RICHMOND COMMUNITY SCHOOL
Richmond High School: Mechanical Modernization Project
LWC Commission No. 20104.02

ADDENDUM #02
September 24, 2021

LWC, Inc.
712 EAST MAIN ST
RICHMOND, IN 47374

STRUCTURAL PLANS	
Comm. No.	Date
20104.02	08.27.2021
Drawn	Drawing No.
VM	S100
Checked	TAC

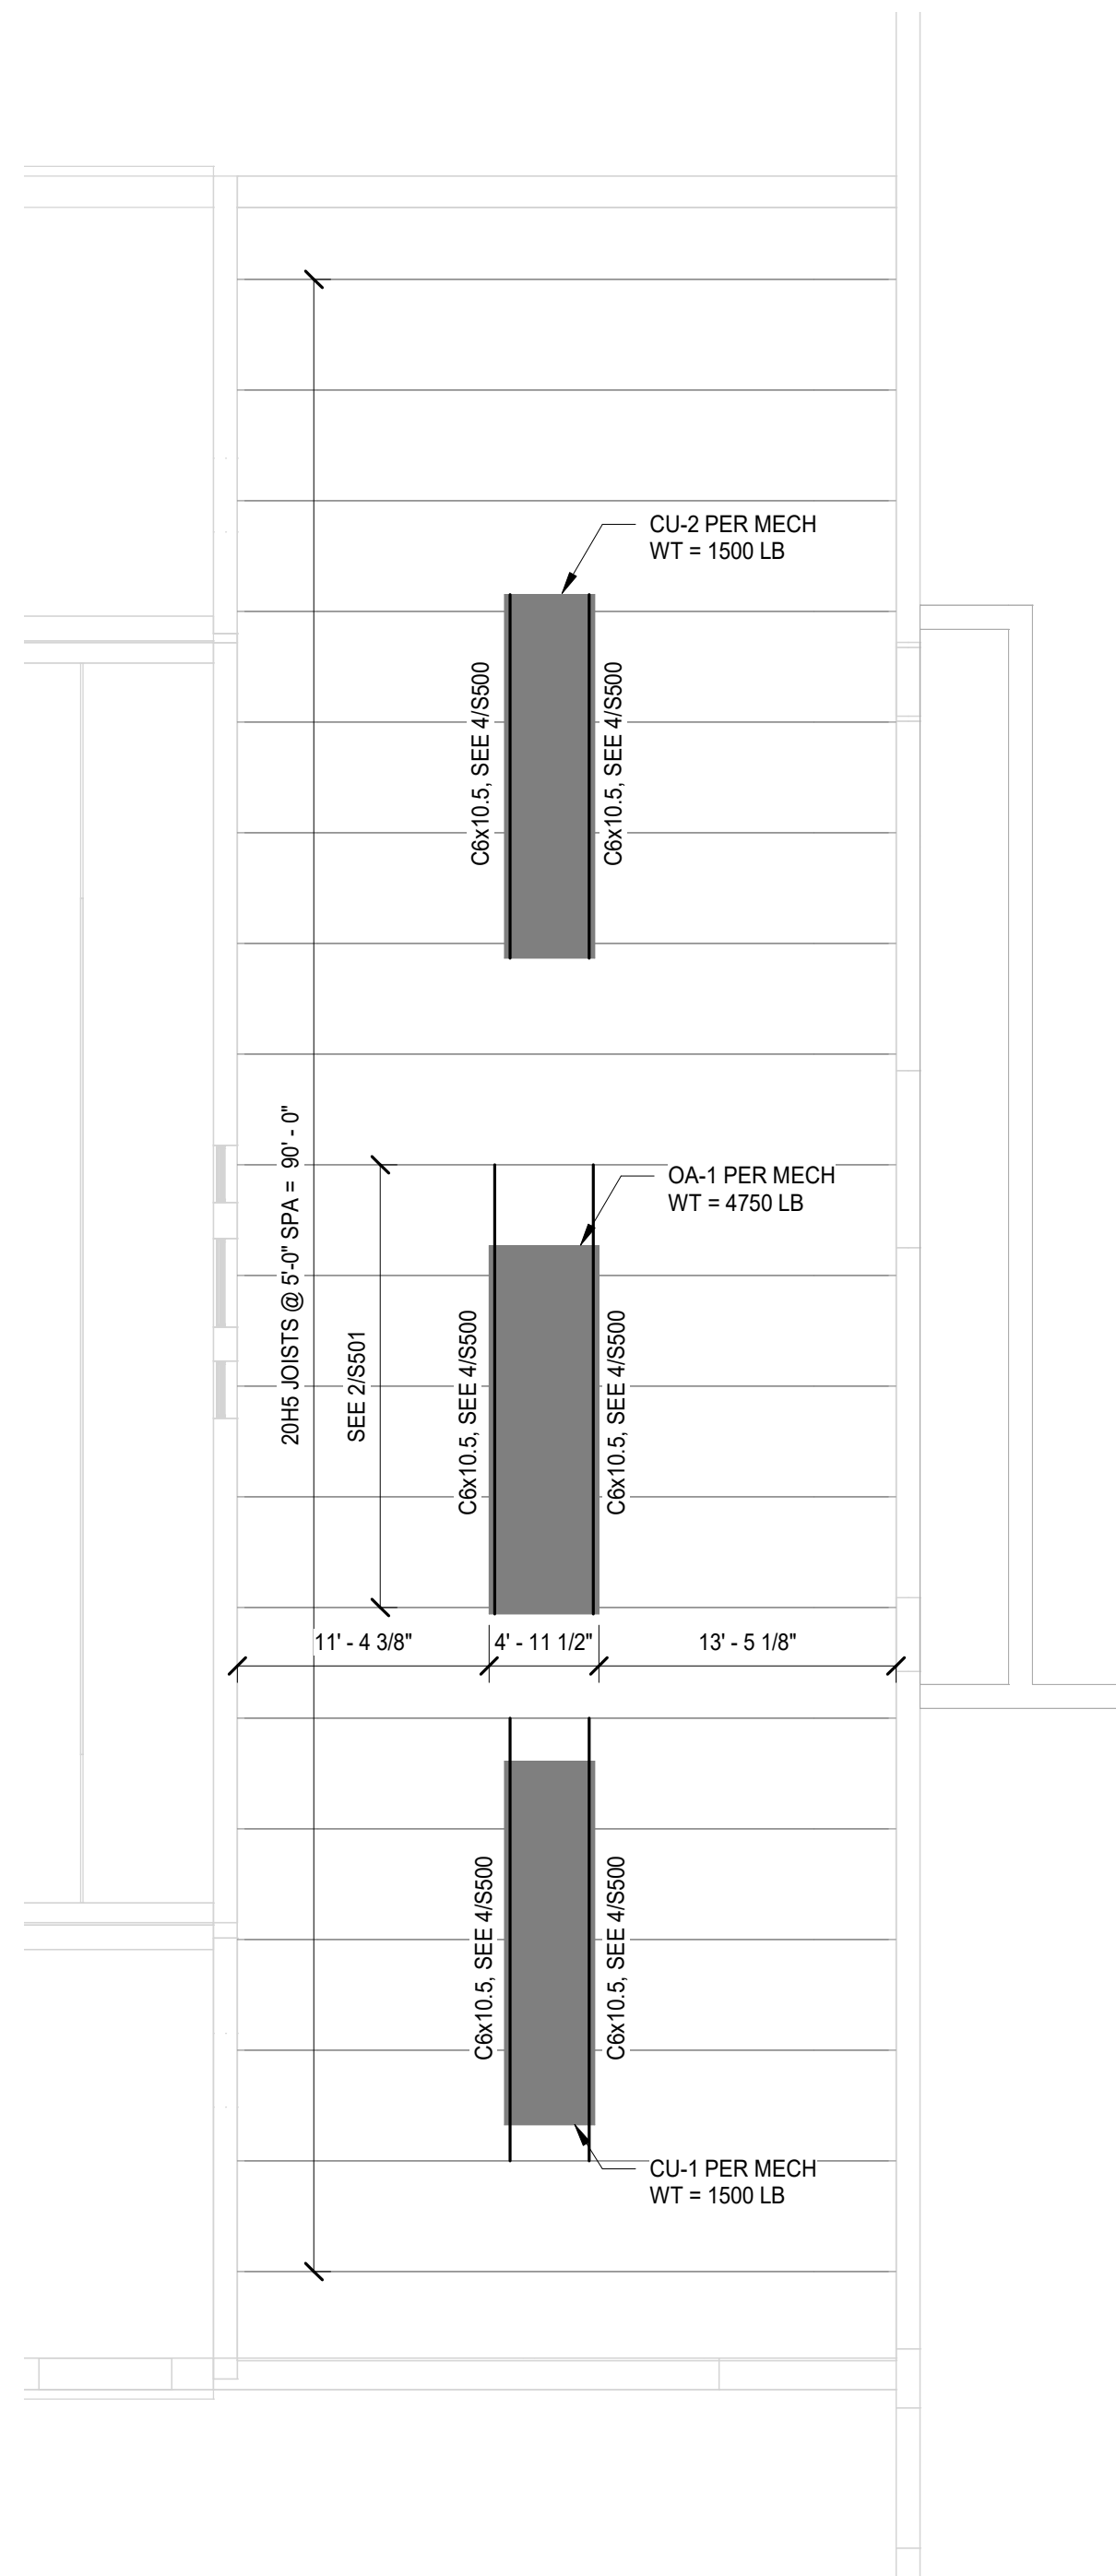
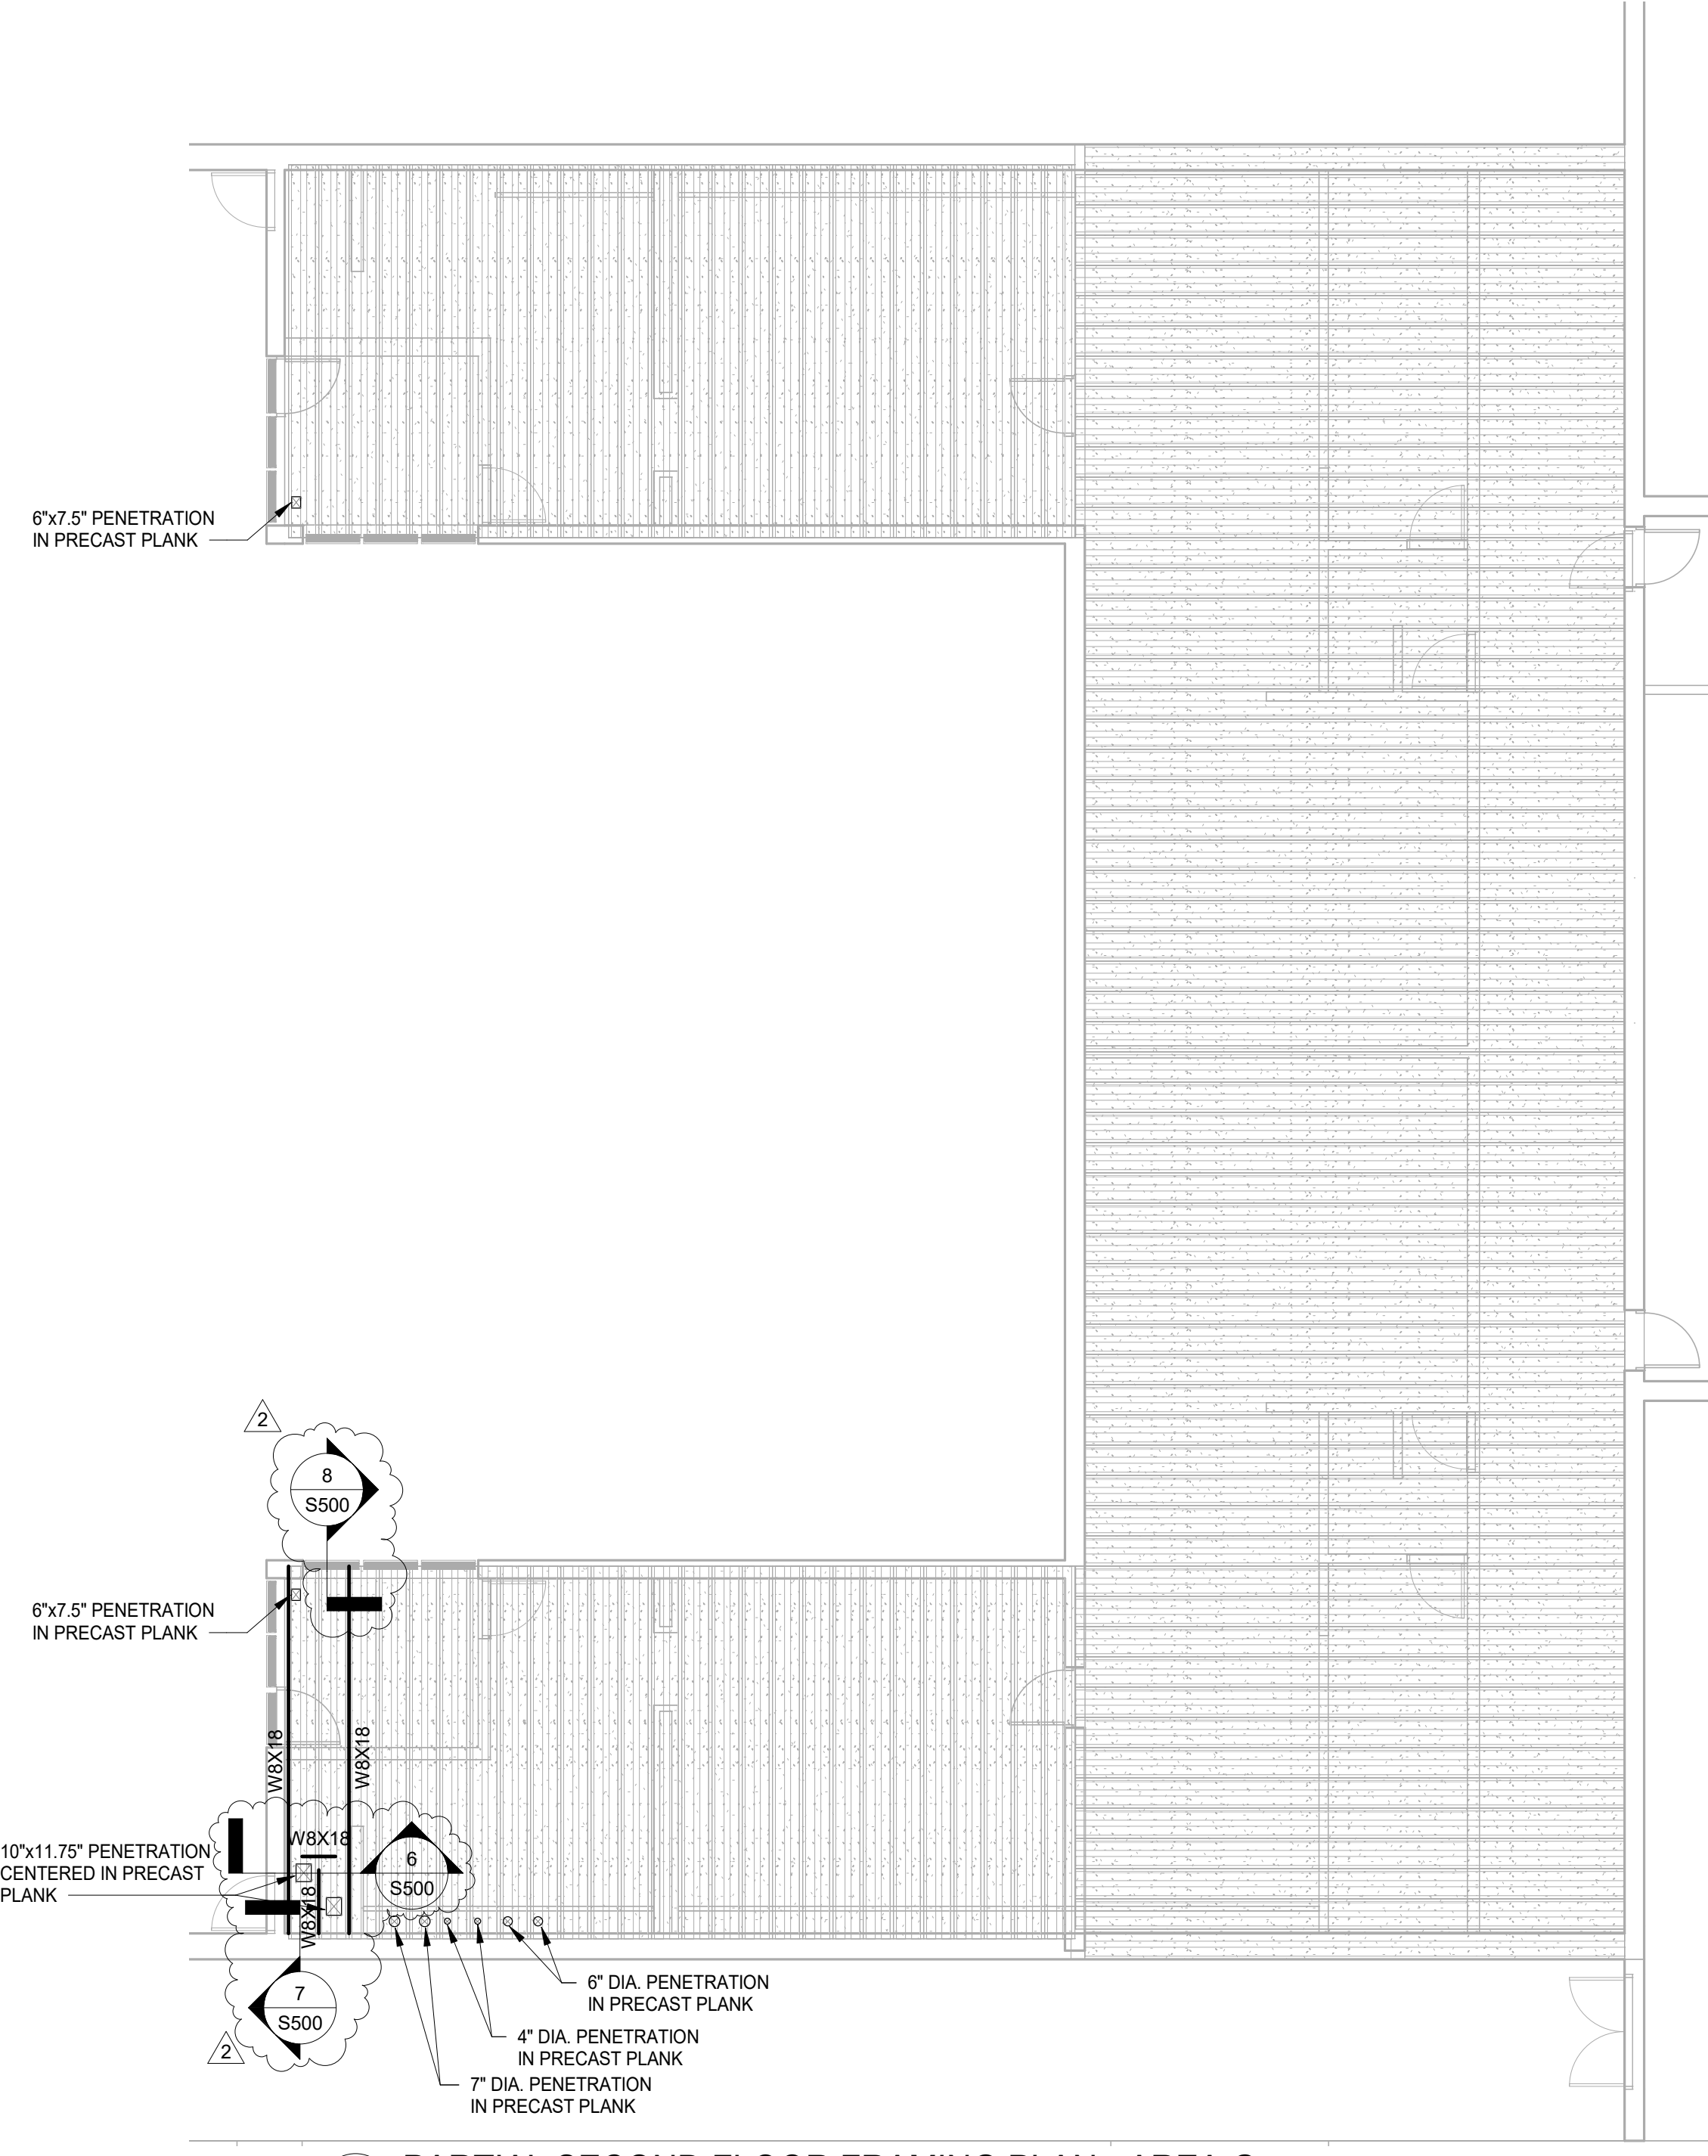
- A. Add Section callouts at southwest corner of second floor Area G. See attached drawing.

Comm. No.	Date
20104.02	08.27.2021
Drawn	Drawing No.
VM	S500
Checked	TAC

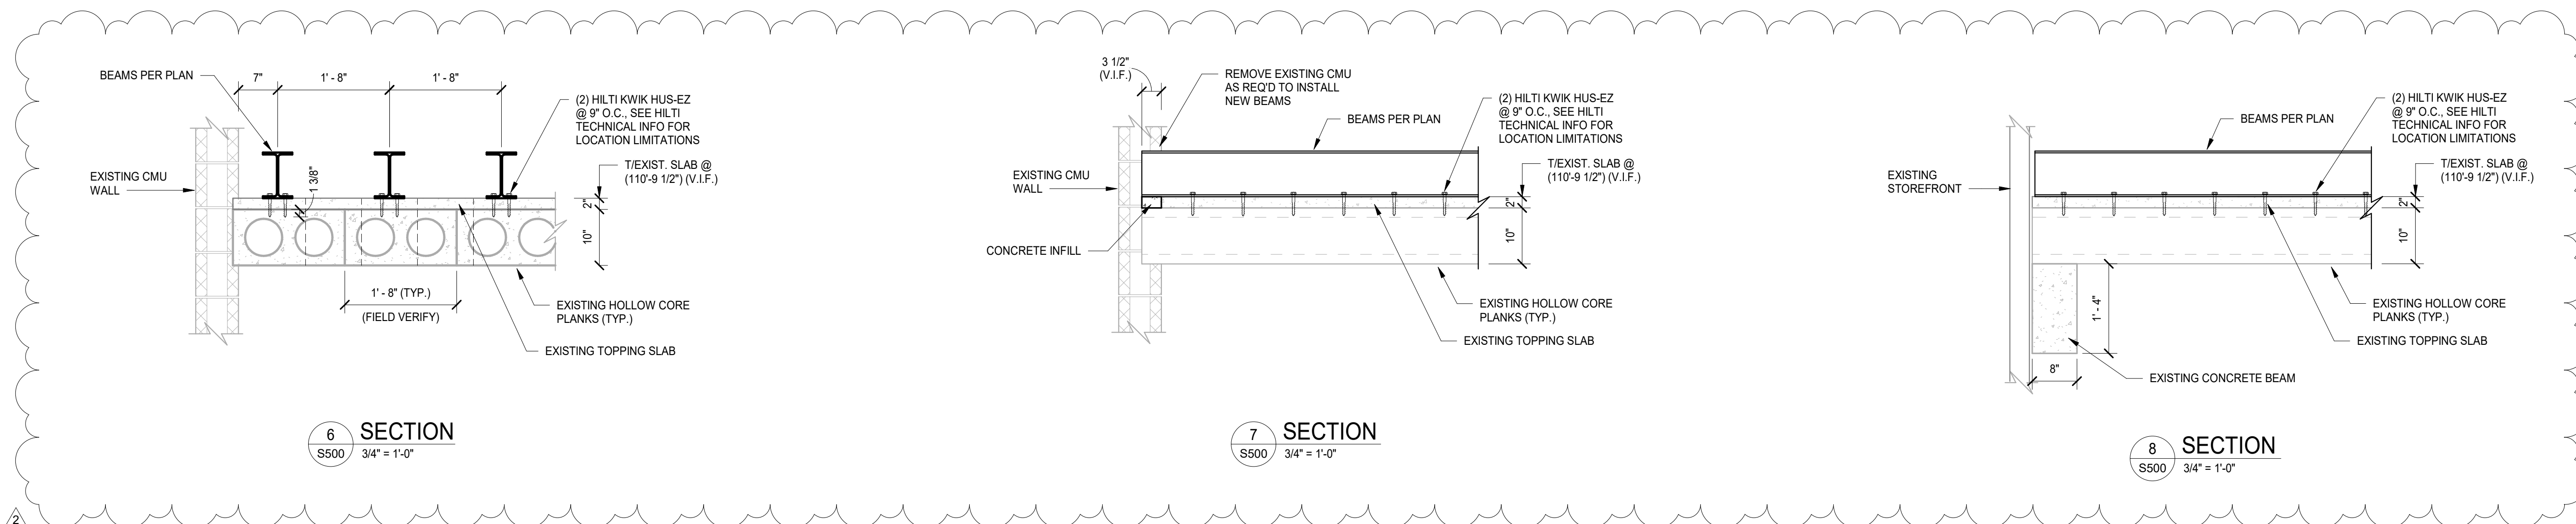
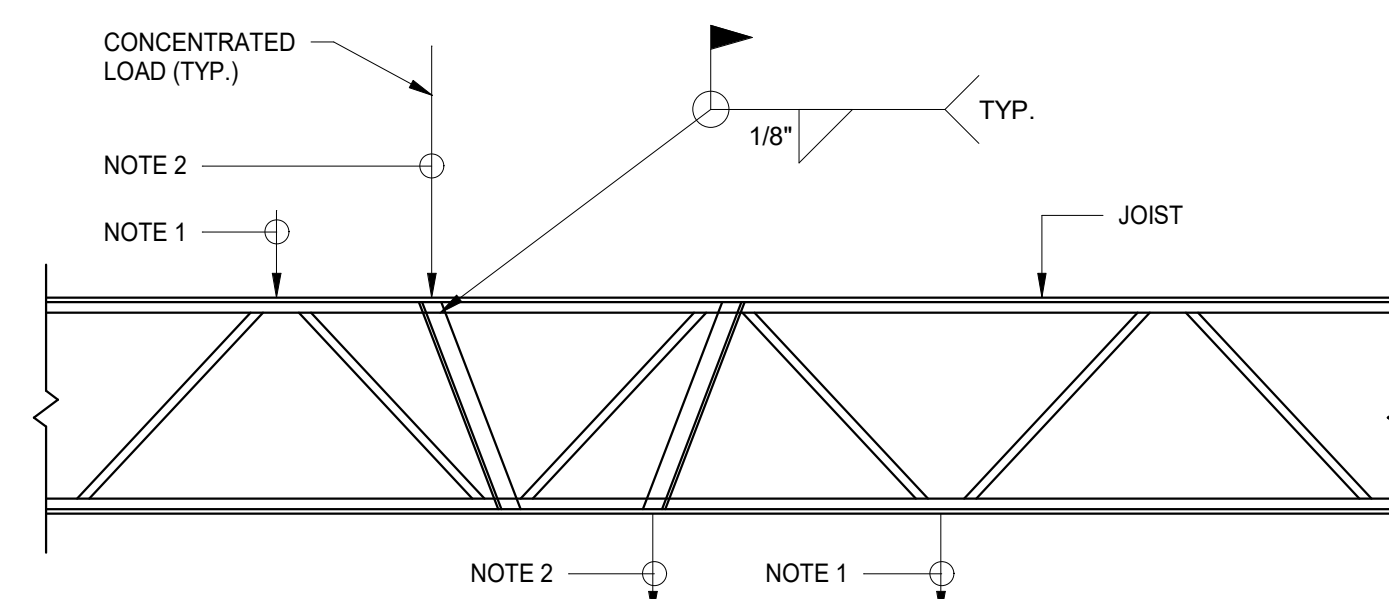
- A. Add Sections 6-8 as shown on attached drawing.
